ADDENDUM NUMBER 02

DATE: May 12, 2026

PROJECT: **CHEAHA STATE PARK FIRE STATION**

PROJECT NUMBER: **ASPD PROJECT #: 2026-005-16FS**

PROJECT NO: R08325001
 DATE: 04/17/2026
 SHEET NO: A05.10
 SCALE: AS SHOWN
 DRAWING TITLE: EXTERIOR WALL SECTIONS

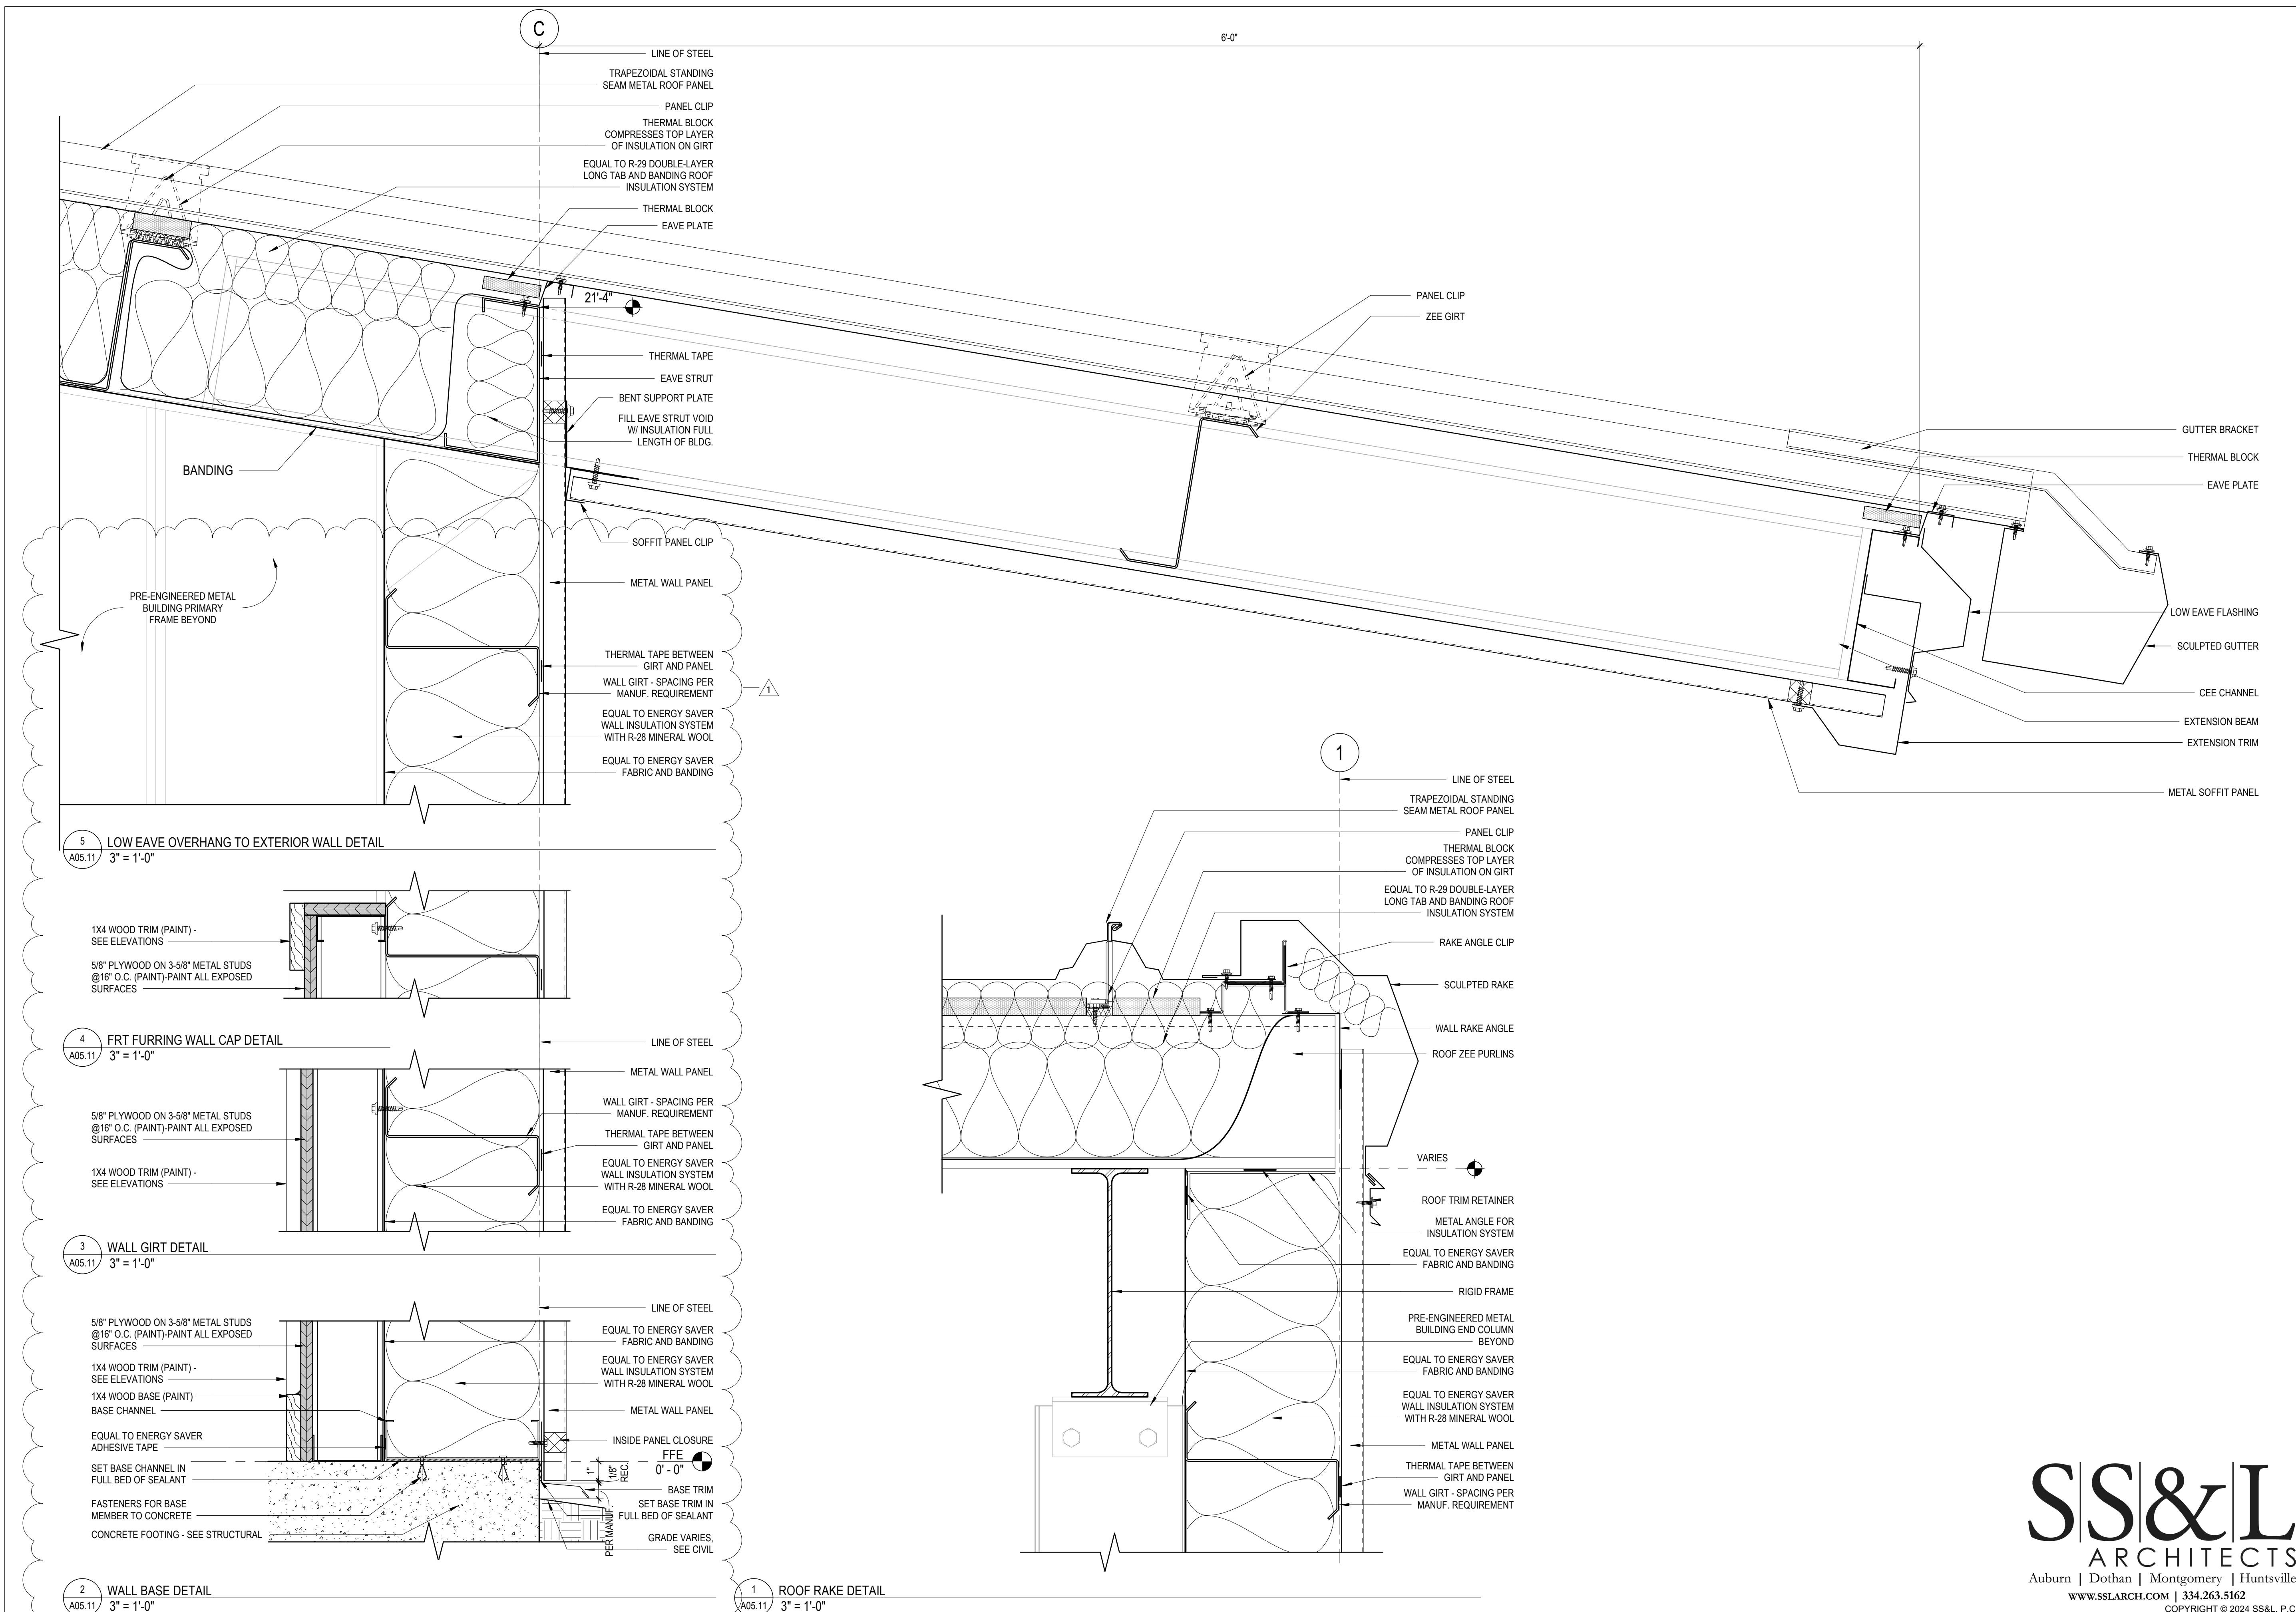
- a. Replace with the attached revised drawing.
 - b. Revision cloud reflects layout of mechanical pad.
6. **Sheet A05-10 – EXTERIOR WALL SECTIONS**
 - a. Replace with the attached revised drawing.

- b. Revision cloud reflects detail numbering change and coiling door section height shifted to match schedule.
7. **Sheet A05-11 – EXTERIOR WALL SECTIONS**

4 FRT FURRING WALL CAP DETAIL
A05.11 3" = 1'-0"

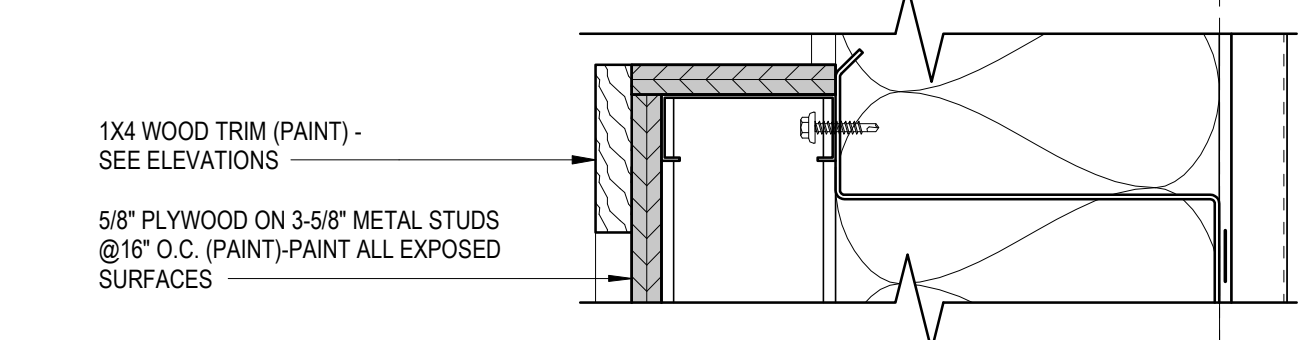
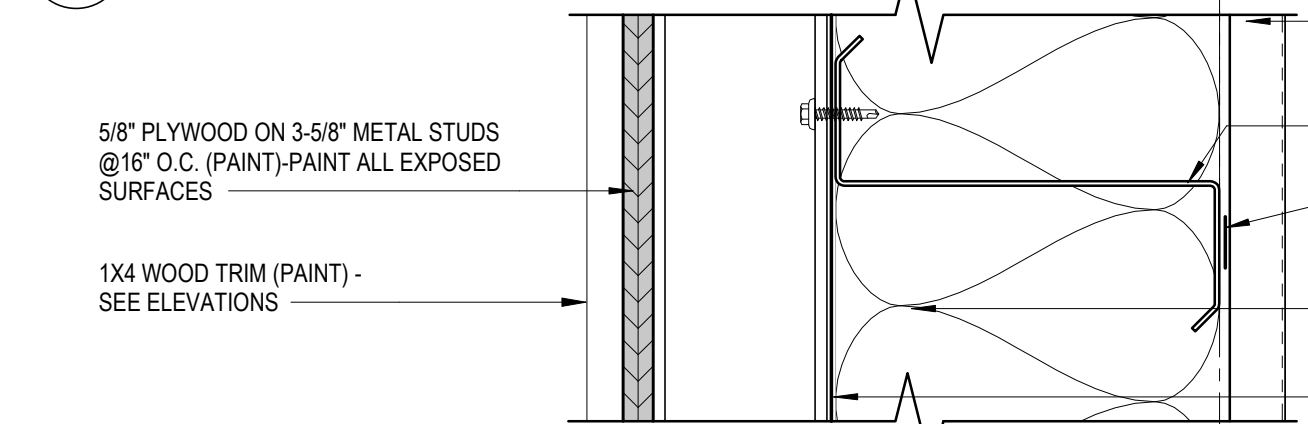
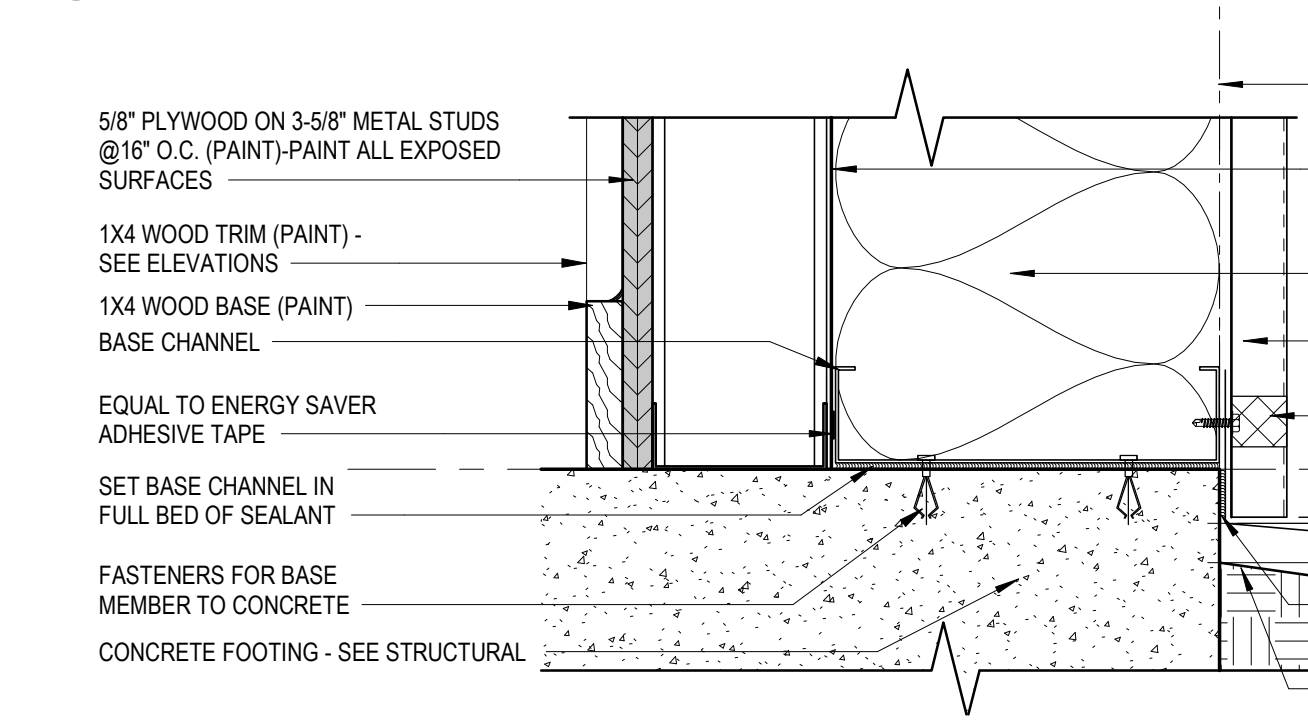
- a. Replace with the attached revised drawing.
 - b. Revision cloud reflects detail numbering change and the addition of FRT wall cap detail.
8. **Sheet A06-01 – ENLARGED STAIR FLOOR PLAN AND ELEVATION**
